Stage 2 Road Safety Audit

Document: JU/RSA2/001 Version: 1

Radstock Regeneration Infrastructure Works

06 December 2013

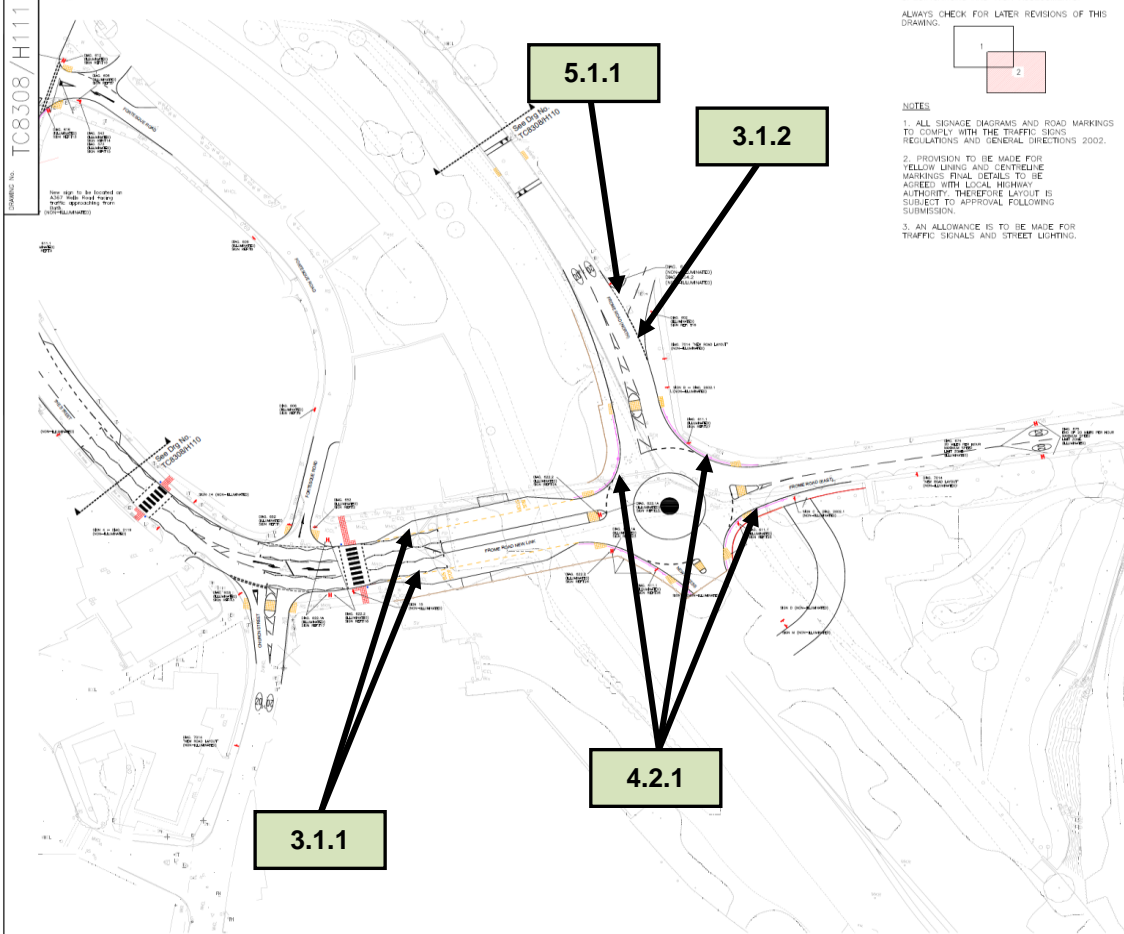
Summary: Proposed “No Entry” sign may be confusing to road users

Drawing TC8308/H111 shows a proposed “No Entry” sign with a supplementary plate “Except Local Buses” installed at the junction. The orientation of the sign is such that drivers travelling north on Frome Road(North) may believe the sign applies to Frome Road. This could lead to driver confusion and late braking or turning movements at the junction.

Summary: Signs mounted at incorrect mounting heights/clearances could be hazardous to all road users

No details have been provided of mounting heights or horizontal clearances of the proposed road signs. Signs installed at the incorrect mounting heights on footways or at the incorrect clearance from the edge of the carriageway could be hazardous to all road users.

Recommendation

Align the sign so it is clear that it is intended for the side road. A map type advanced sign such as that illustrated in Figure 15-14 in Chapter 3 of the Traffic Signs Manual could also help to explain the layout to drivers in advance of the junction.

Recommendation

Ensure signs are mounted at the correct mounting heights and clearances as per the guidance given in TSRGD 2002.

DRAWING No. TC8308/H139

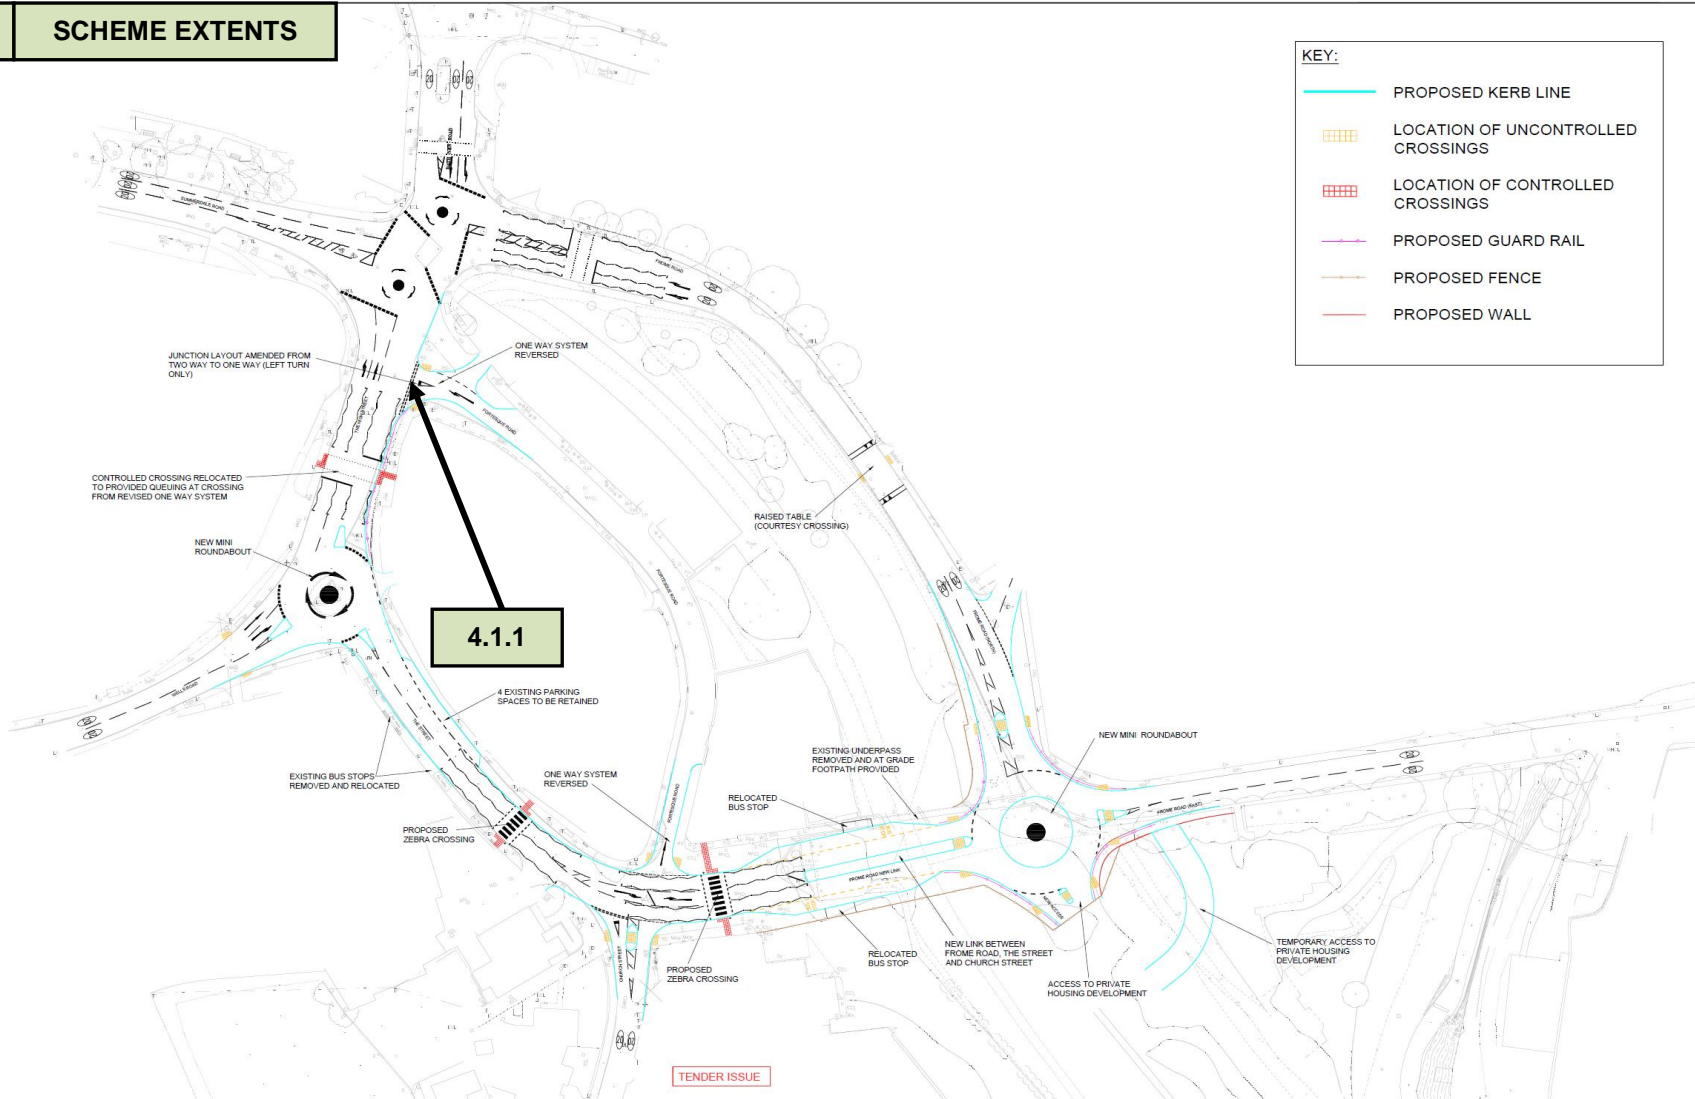
Summary: Junction alignment may not deter drivers from turning right out of Fortesque Road in violation of turning ban

Under the proposals, drivers will only be permitted to turn left from Fortesque Road onto the High Street. The Audit Team are concerned that despite signing/road markings, the proposed approach alignment of the junction may still encourage drivers to make the banned right turn movement which could increase the risk of conflicts occurring.

Summary: Pedestrian guardrail could interfere with visibility for drivers on the roundabout and also mask children/buggies or wheelchairs waiting to cross

Pedestrian guard rail has been proposed on all arms of the new roundabout. Care should be taken to ensure that the guardrail does not interfere with the sightlines for drivers entering the roundabout as failure to provide adequate visibility could increase the risk of failure to give way type collisions. In addition, the guardrail would significantly narrow the footway width (if installed at the correct clearance) and also could mask children, buggies or wheelchairs waiting at the crossing points.

Modify the junction alignment to physically deter drivers from turning right from Fortesque Road. This would also have the added benefit of reducing the crossing distance for pedestrians.

Given that pedestrian crossing provision has been provided across all arms of the roundabout, it is not clear why the guardrail is required and therefore it is recommended that it is removed from the design proposals.
